UNITED STATES ENVIRONMENTAL PROTECTION AGENCY

Re: Upper Skagit Indian Tribe Water Reclamation Facility

Re: Upper Skagit Indian Tribe, Proposed Water Reclamation Facility
Response to February 4, 2009 EPA Comment Letter

Re: Underground Injection Control Program
Authorization by Rule of Two Injection Wells for Disposal of Wastewater Treatment
Plant Effluent, Upper Skagit Indian Tribe Water Reclamation Facility
UIC ID # WA425T5-17-13494

MW-3 Hydrograph

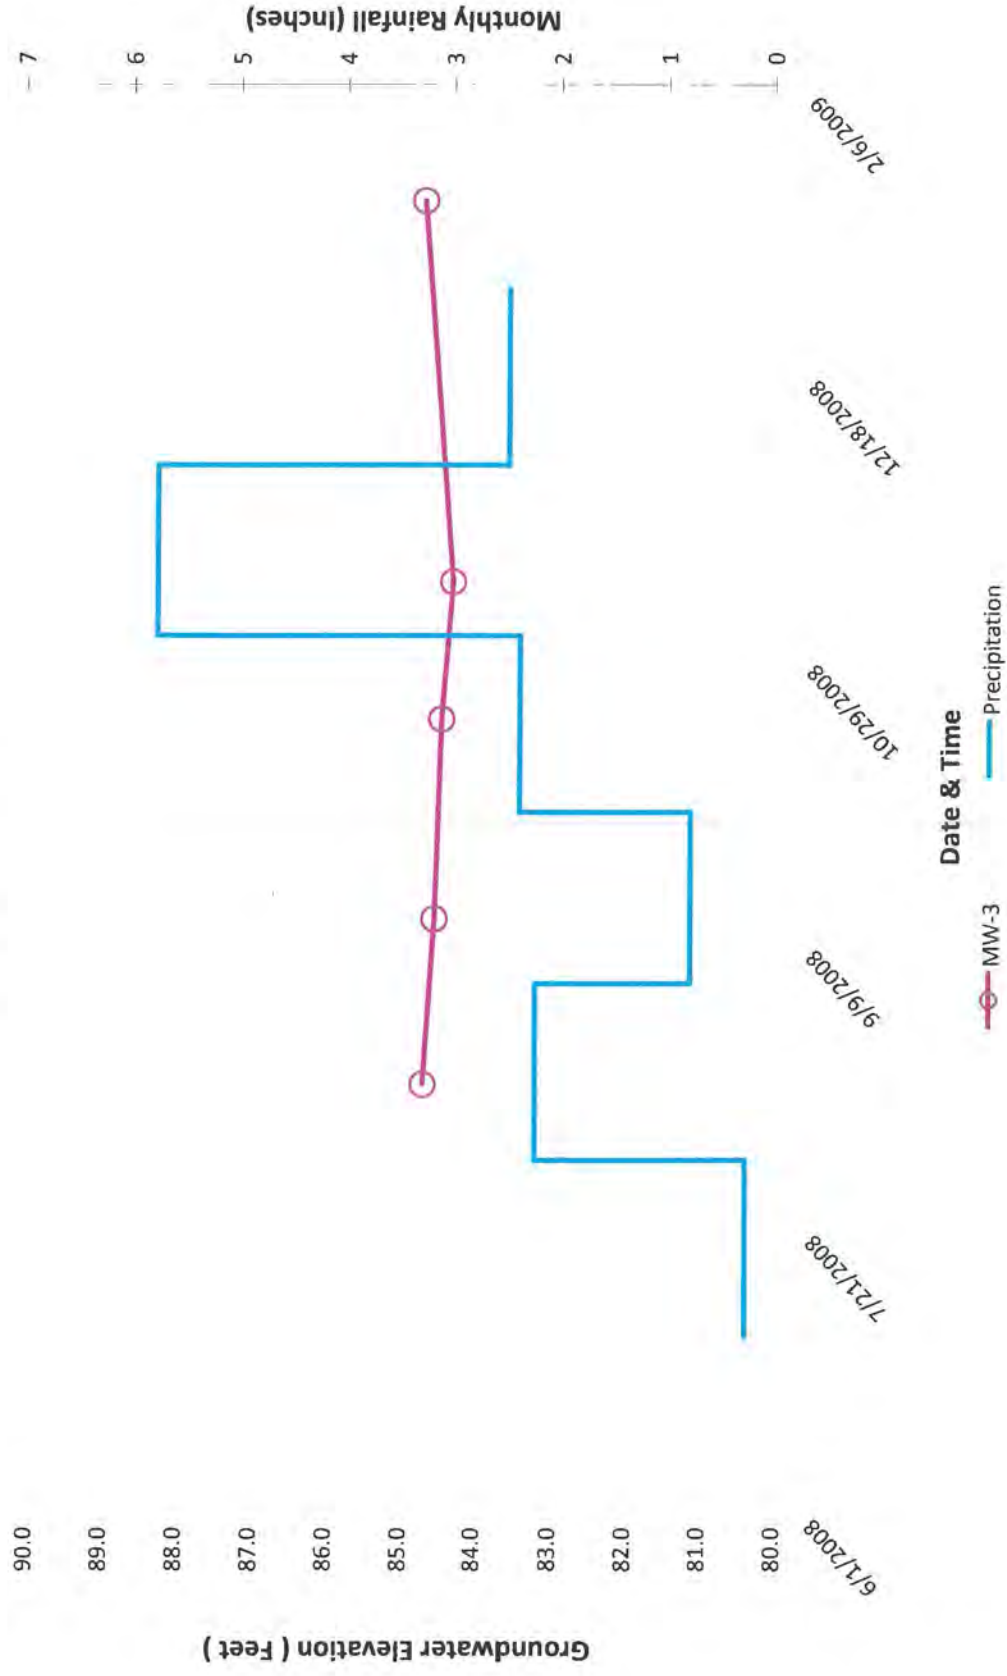
2. The Vashon Advance Outwash aquifer is reported to be unconfined. The proposed injection well design specifies that the base of the injection wells will be located 140 feet below ground surface to allow for a 20-foot separation distance between the points of discharge at the base of the injection wells and the top of the saturated zone at approximately 160 feet below ground surface. However, the well logs provided for monitoring wells 2A and 2B (the wells located closest to the proposed injection wells) show that ground water was detected at 45 feet below ground surface in both wells when the wells were drilled. In addition, the well logs document that the Vashon Glacial Till (the formation overlying the Vashon Advance Outwash) and Vashon Glacial Outwash units are moist to wet in monitoring wells 2A and 2B. Ground water was not measured in wells 2A and 2B during monitoring events in June – September 2008, but monitoring data collected at other times of the year or in conjunction with storm events are not included in the inventory submittal. Saturated conditions within the geologic units or

During the meeting Figure 5, the geological cross-section, was reviewed to clarify the 40 foot vertical and 600 foot horizontal separation (minimum distances) between the point of discharge and the Vashon Advance Outwash aquifer. Also the attached long term monitoring data demonstrates that the aquifer level and the above listed 40 foot and 600 foot separations between the effluent discharge point and the aquifer do not fluctuate seasonally. See attached hydrographs for MW-1, MW-3, and DW-1. Hydrographs for MW-2A and MW-2B are not included because these two monitor wells have remained dry throughout the monitoring period.

- Overall Site Layout with Existing and Proposed Monitor Well Locations
- Facility Layout with Proposed Up-Gradient Monitor Well Location

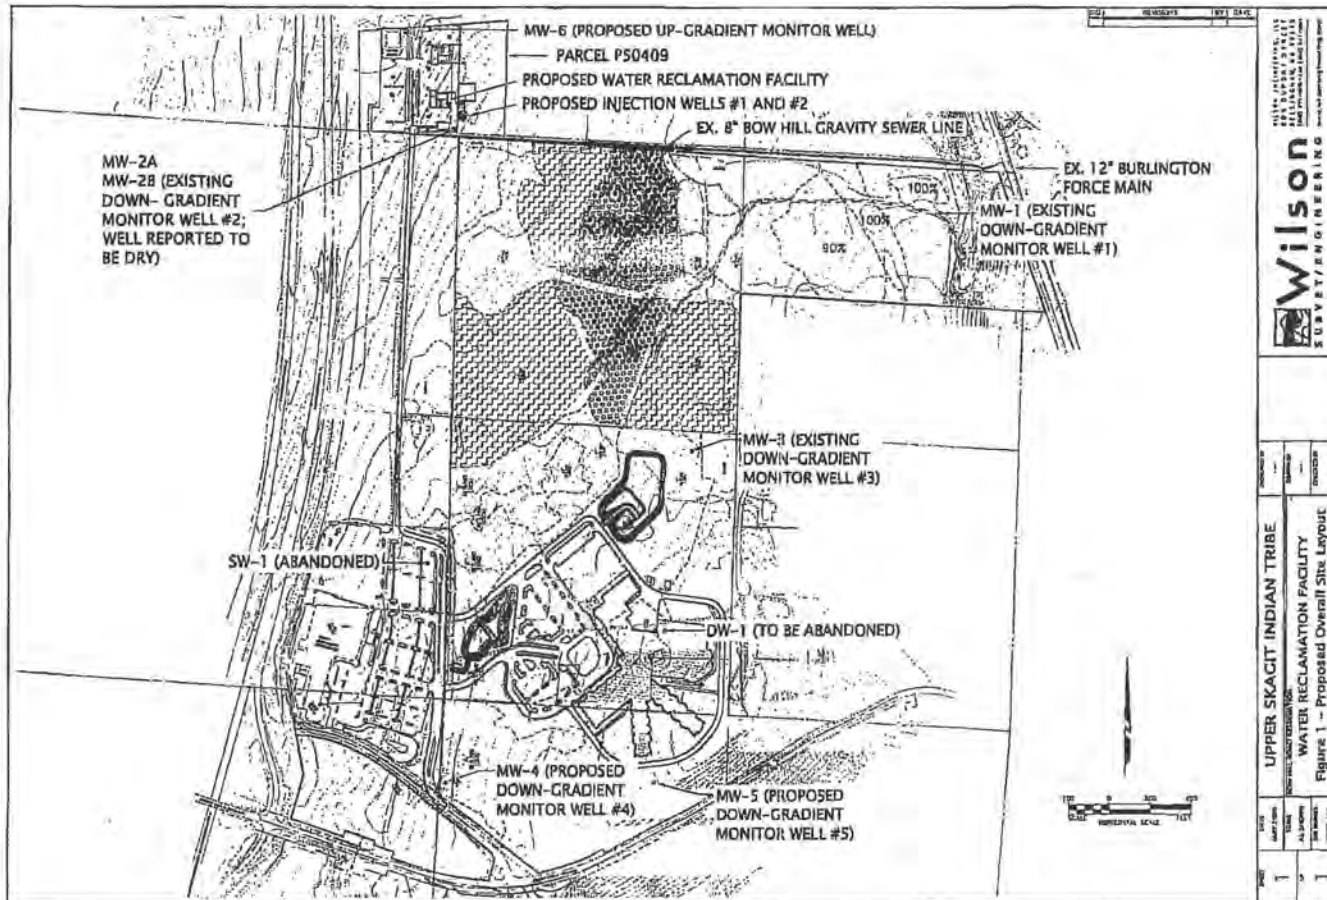
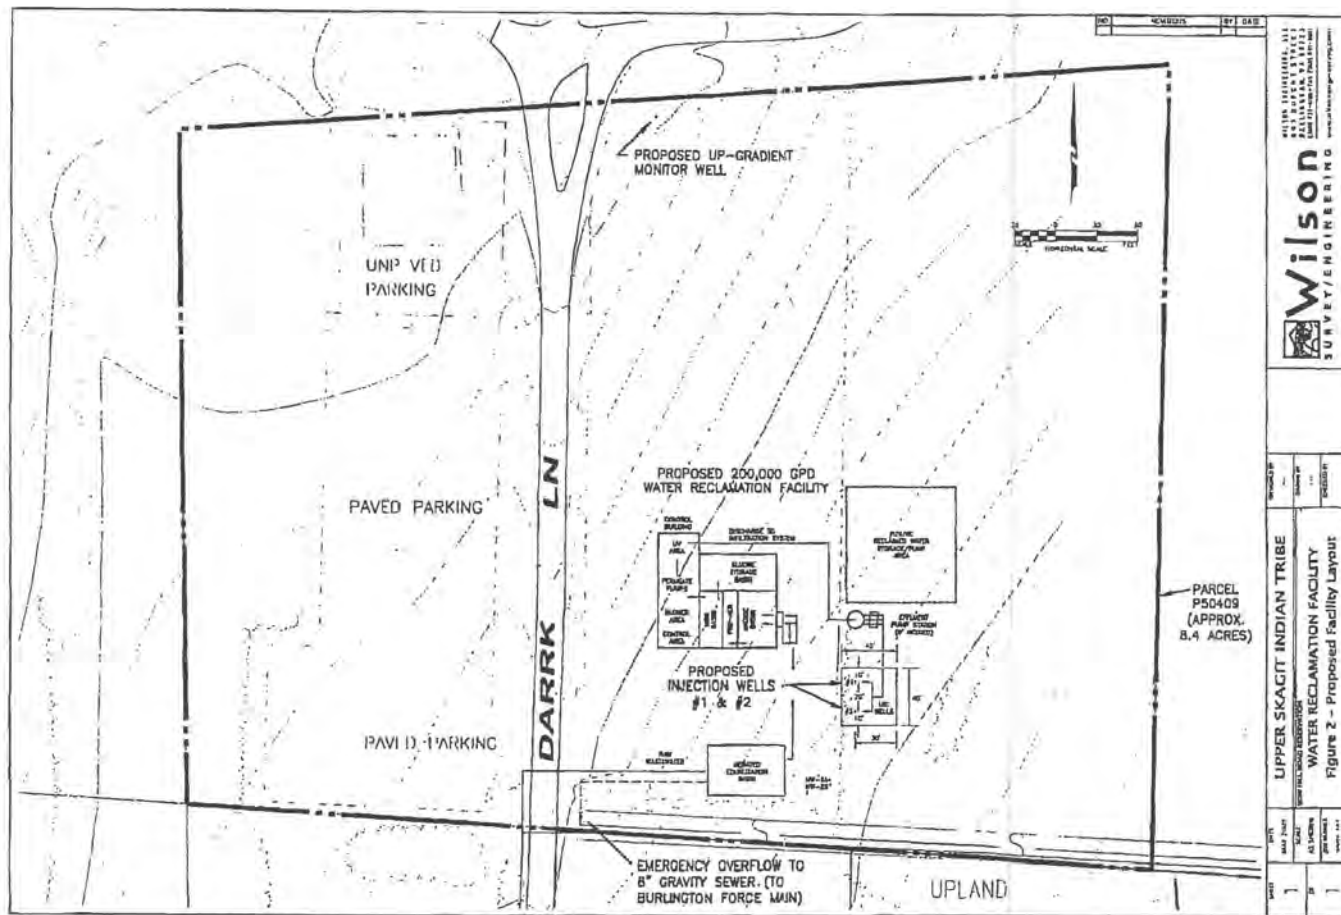
3. Four monitoring wells were installed during the site investigation and design phase of this project. If injection occurs at this site, additional monitoring wells would be necessary to evaluate potential impacts to the USDW from the injection operations. At other reclamation plants of similar design, at least one monitoring well is installed in an up-gradient direction, to establish background water quality, and a line of monitoring wells are typically installed down-gradient from the injection point at locations where they are most likely to intercept the injected effluent.
4. If injection occurs at this site, a quality assurance plan for sampling and analysis should be established. The sampling and analysis plan should be designed to evaluate whether injection activities introduce contaminants into the USDW.

An up-gradient monitor well will be installed; however, the hydrogeological report indicates that the aquifer does not exist up-gradient and proposed well will likely be dry. See attached site plan for proposed monitor well location.
